EIT Test Channel Return Loss

Tyco Electronics

February 2, 2006

Channel Data Review

NewTTC23withCoupler.s4p

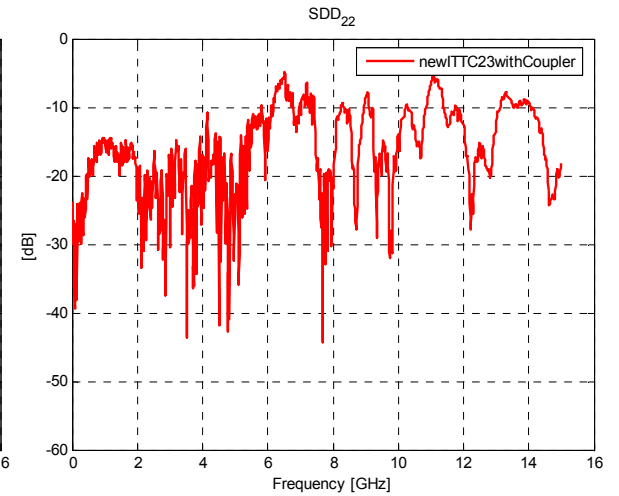
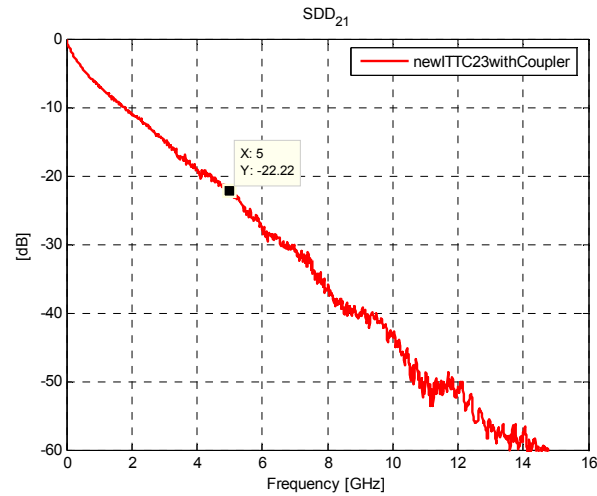
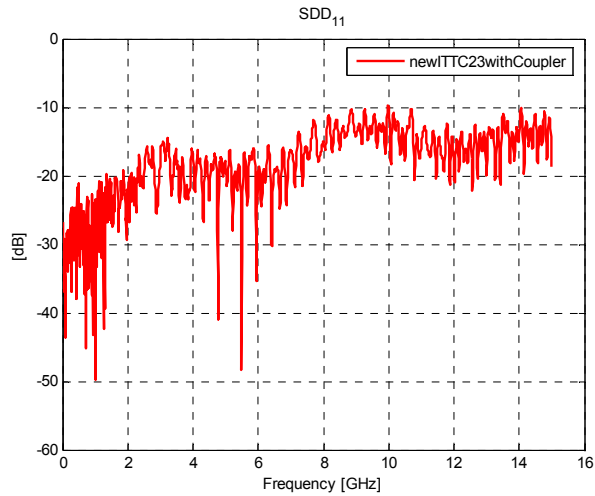
File is not TP1 to TP4 only and includes effects of the Rx daughtercard.

- In 69A.2.2
- EIT Test Channel SDD11 / 22 < -20
- For f_{min} to f_2
